#### APPEAL SUMMARY

<b>Appeal ID:</b> 24409	<b>Project Address:</b> 1111 SE Tenino St
<b>Hearing Date:</b> 11/25/20	<b>Appellant Name:</b> Edward Radulescu
<b>Case No.:</b> B-014	<b>Appellant Phone:</b> 5036792493
<b>Appeal Type:</b> Building	<b>Plans Examiner/Inspector:</b> Sloan Shelton
<b>Project Type:</b> commercial	<b>Stories:</b> 3 <b>Occupancy:</b> R-2 <b>Construction Type:</b> V-B
<b>Building/Business Name:</b> SE 11th Apartments 1	<b>Fire Sprinklers:</b> Yes - NFPA 13R Throughout
<b>Appeal Involves:</b> Erection of a new structure	<b>LUR or Permit Application No.:</b> 19-265965-CO
<b>Plan Submitted Option:</b> mail [File 1] [File 2] [File 3] [File 4]	<b>Proposed use:</b> R-2 Apartments

11TH AVE  
19-UNIT APARTMENT HOUSE  
8134 SE 11TH AVE  
PORTLAND, OREGON  
EPR DESIGN

**D REAR ELEVATION (EAST)**  
SCALE: 1/4" = 1'-0"

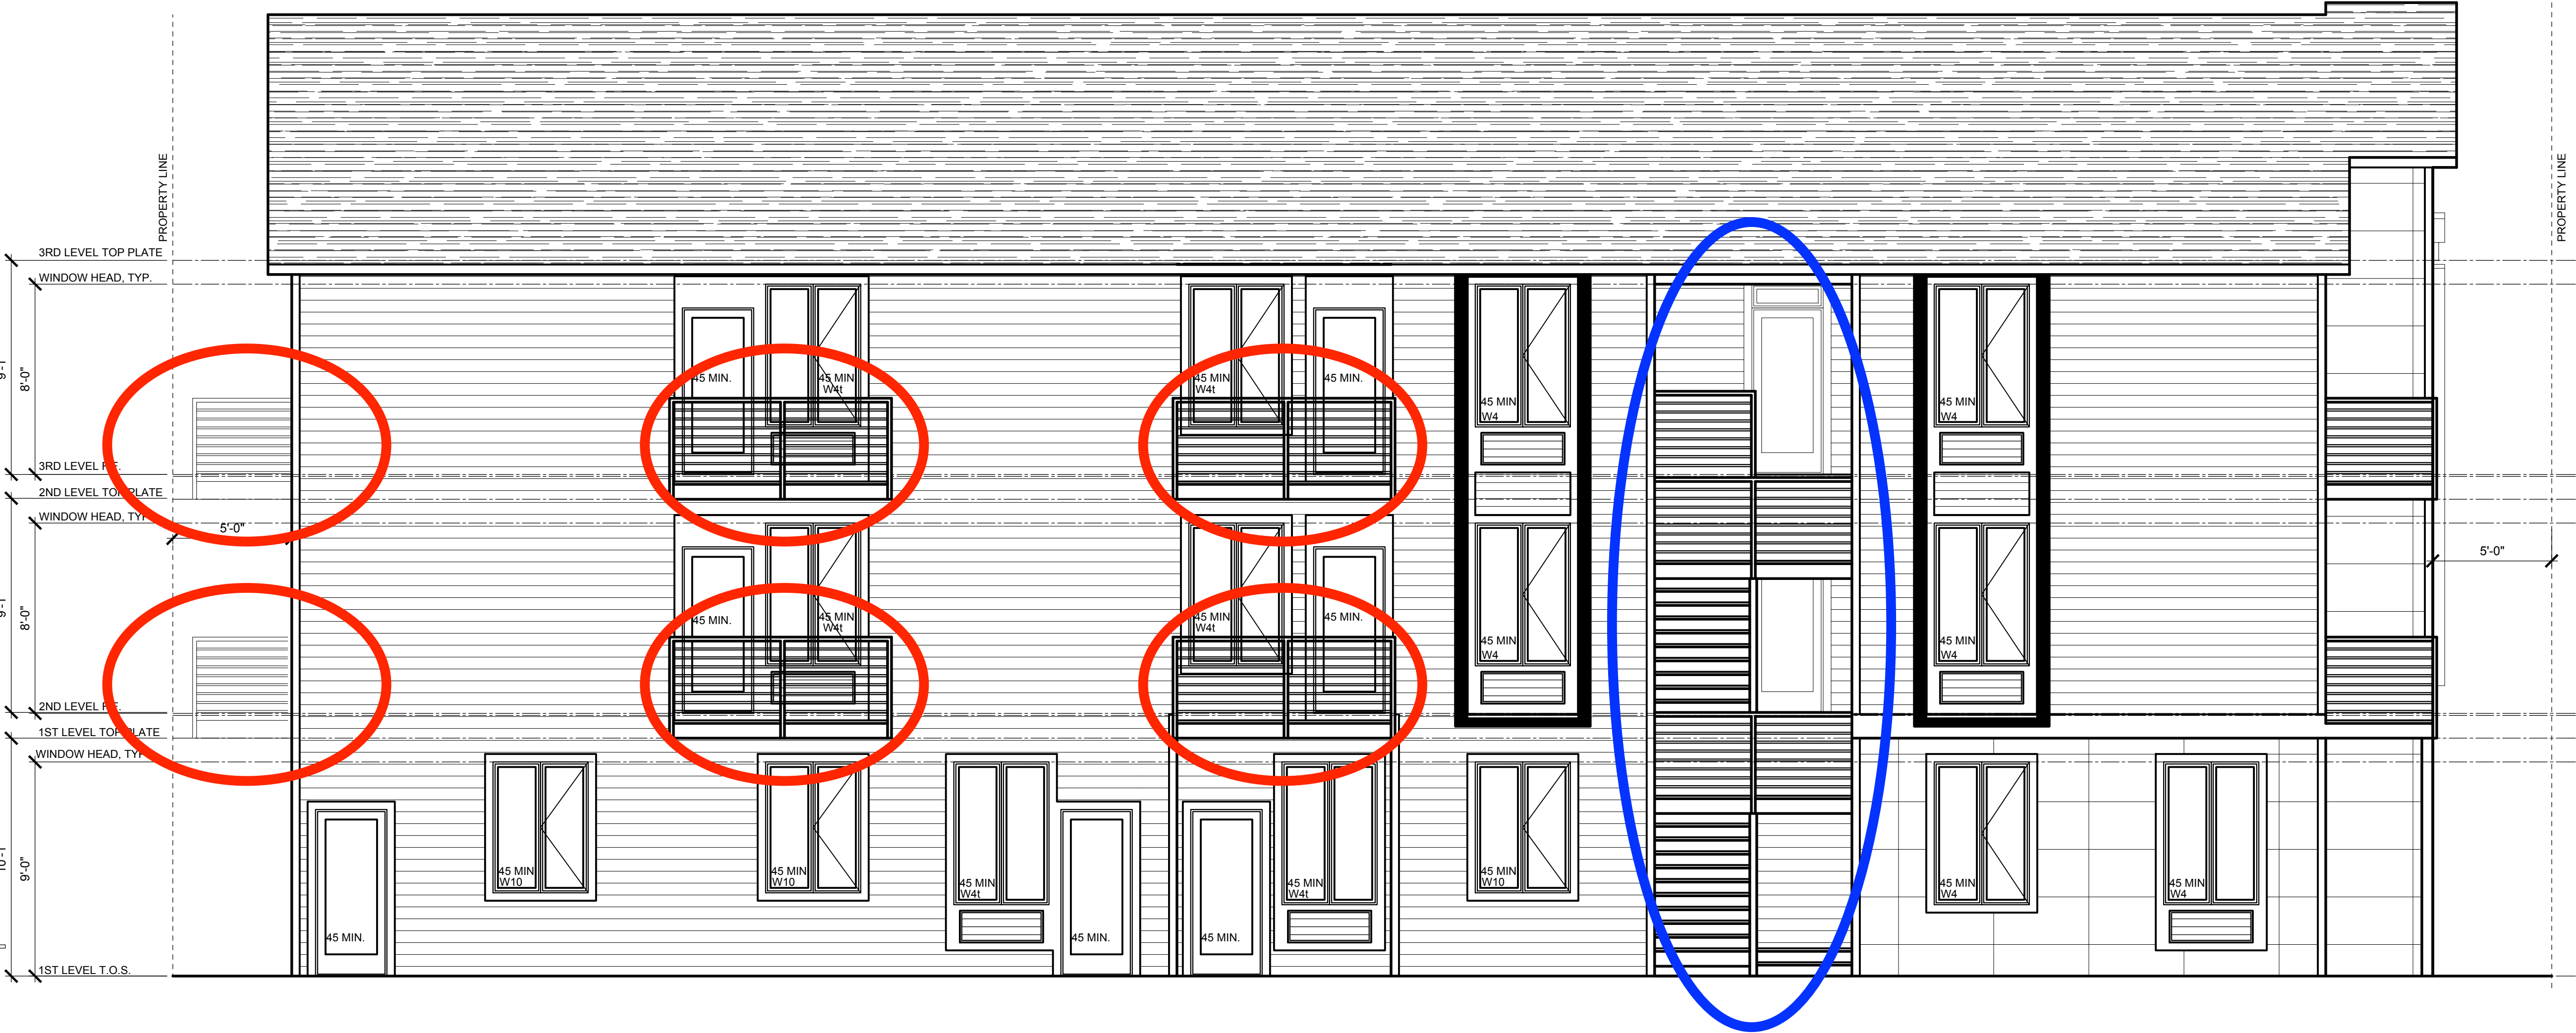
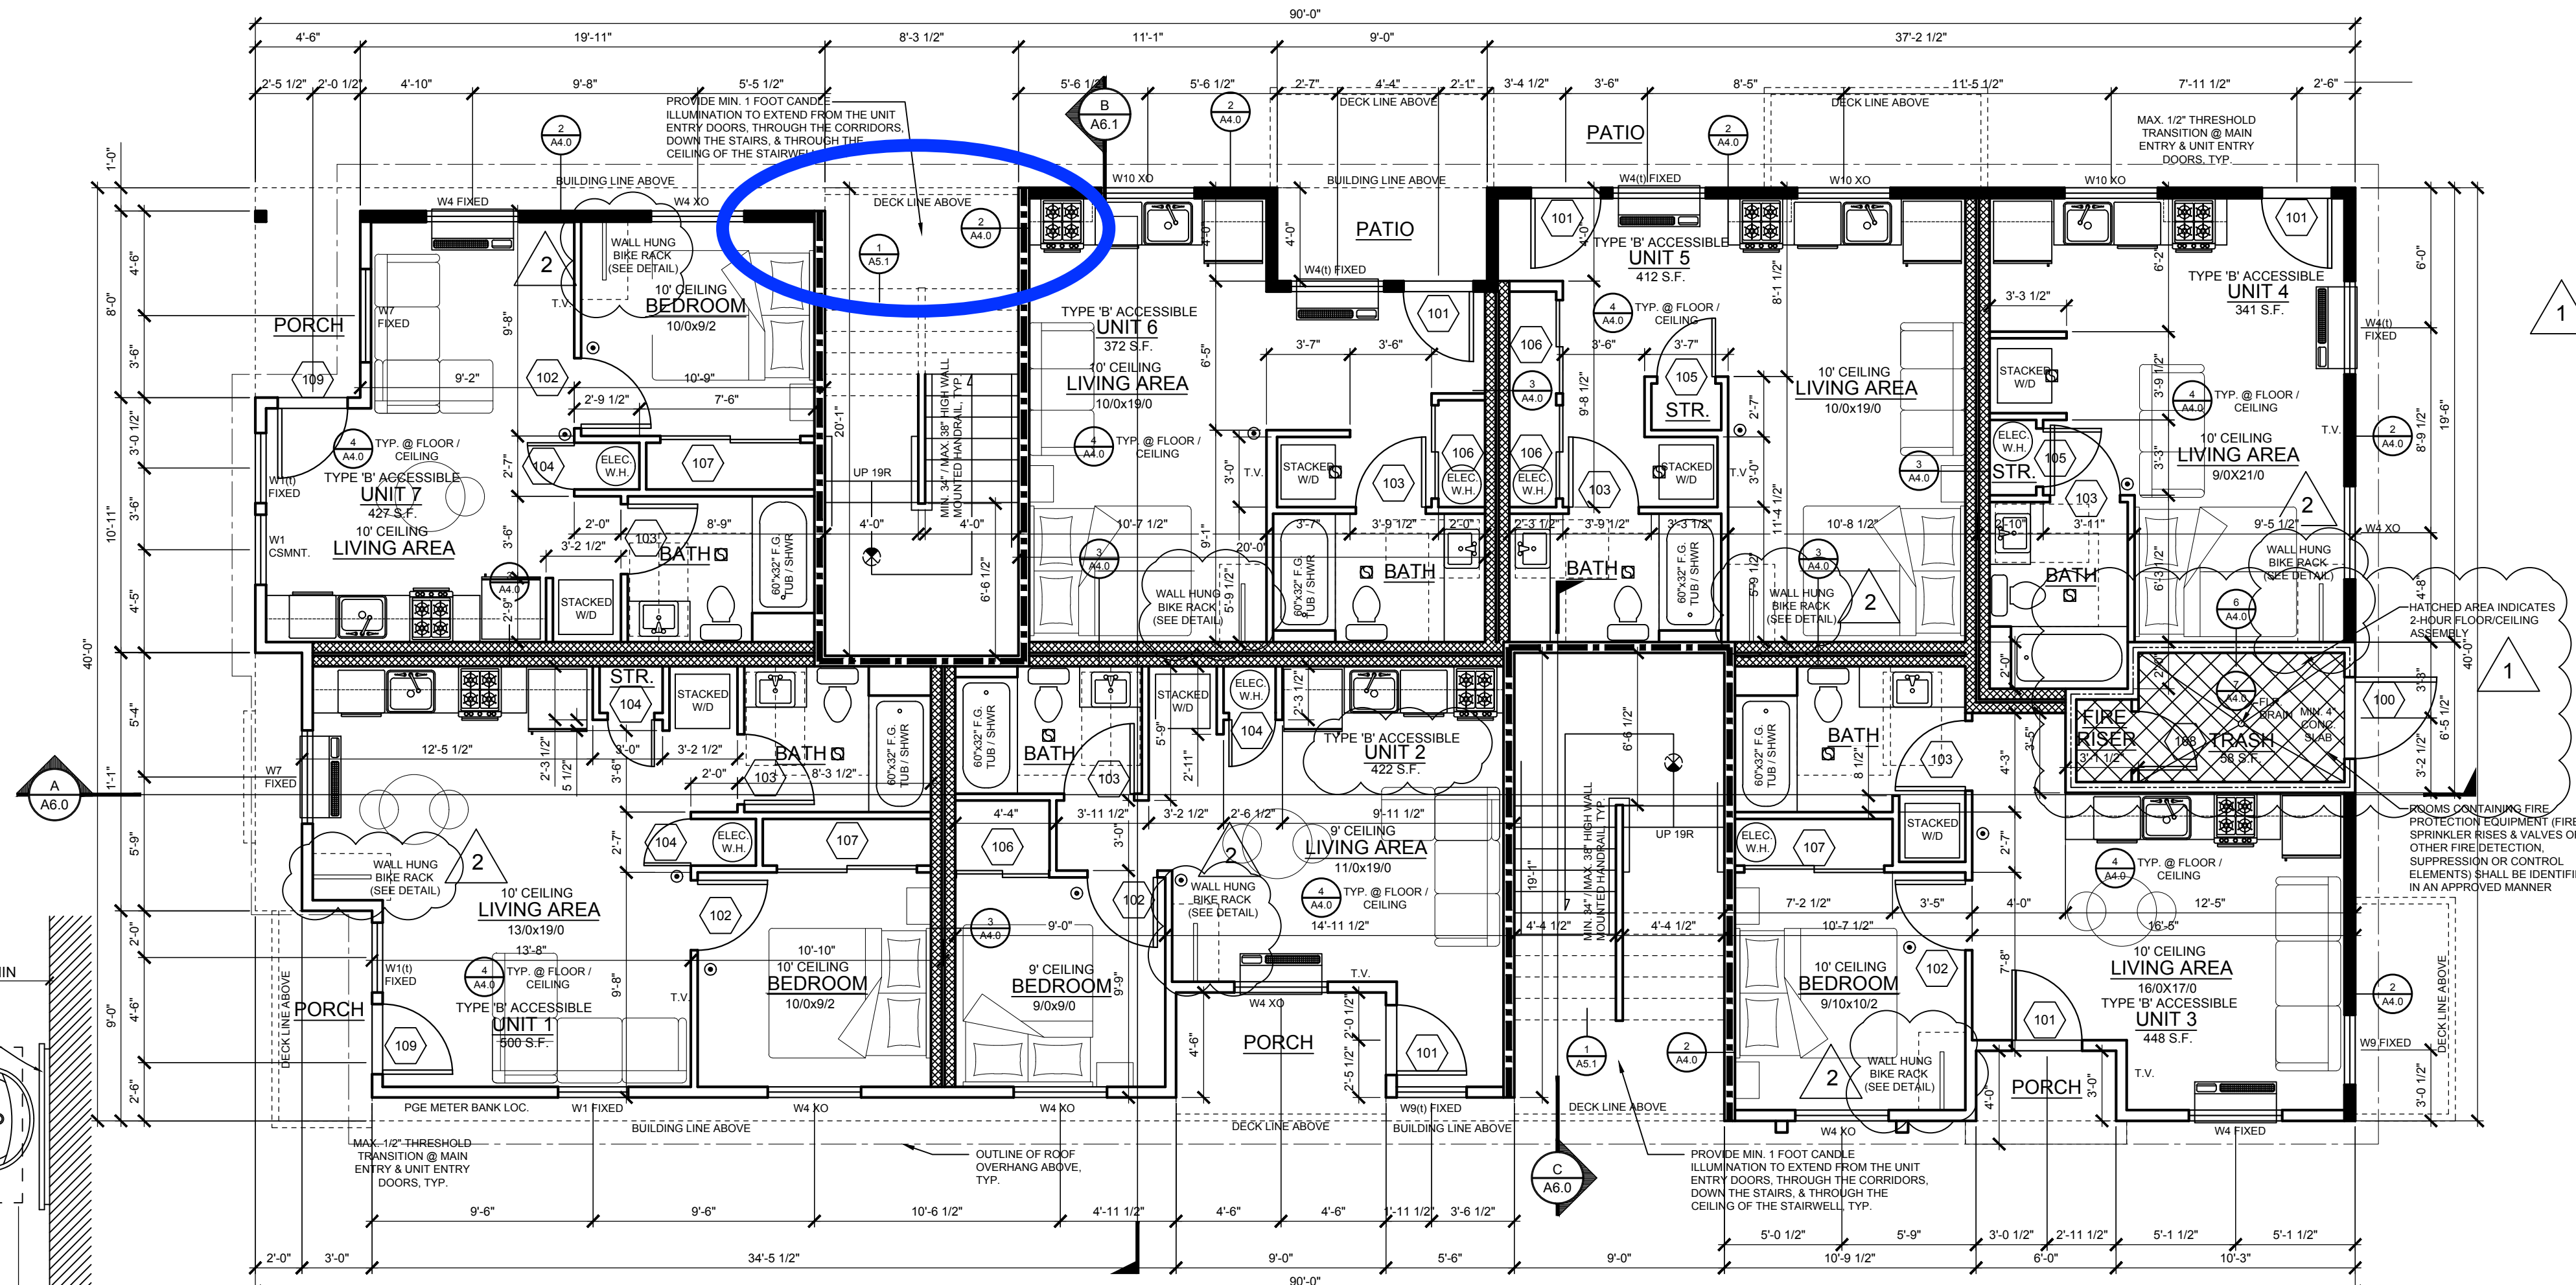
<b>Code Section</b>	705.8, 1027.5
<b>Requires</b>	Openings in exterior walls shall comply with Section 705.8.1 through 705.8.6.2. Table 705.8 allows for openings in a wall with a fire separation distance of 5' to less than 10' and where the openings are unprotected but the building is sprinklered to have 25% openings. 1027.5 requires landings at exterior exit stairs to have a fire separation distance of 10'.
<b>Code Modification or Alternate Requested</b>	The applicant wishes to not have the opening at the exterior stairs be included in the exterior wall opening area calculation and allow the landings to be at a fire separation distance of 5' from the property line.
<b>Proposed Design</b>	The exterior stair on the north side is open on 1 side and has a fire separation distance of 5' at the opening and stair landings from the property line. A water curtain will be proposed at the stair landings on each floor and at the ceiling on the 3rd floor per 705.8.2 in lieu of enclosing the stairs and allowing it to be excluded from the fire separation distance opening area calculation. The exterior walls of the building, including the exterior walls that wrap around the stairs are constructed as 1-hour rated exterior wall assemblies. The exception in 705.8.2 states "Opening protectives are not required where the building is equipped with an automatic sprinkler system in accordance to 903.1.1.1 and the exterior openings are protected by a water curtain using automatic sprinklers approved for that use." The applicant wishes to have this exception apply to the exterior wall opening created by the exterior exit stair.

<b>Reason for alternative</b>	The alternate is to allow for an open air stairway that accesses the units. In order to meet the code the alternate would be to enclose the exit stairs and provide a door. By providing non-combustible materials at the deck, fire sprinklers and water curtain, and 1-hour construction around the exterior stairs the intent for life safety and fire protection is equal to the intent of the code.

**2. Increase in allowable area of exterior wall openings with sprinkler protection: Hold for additional information.**
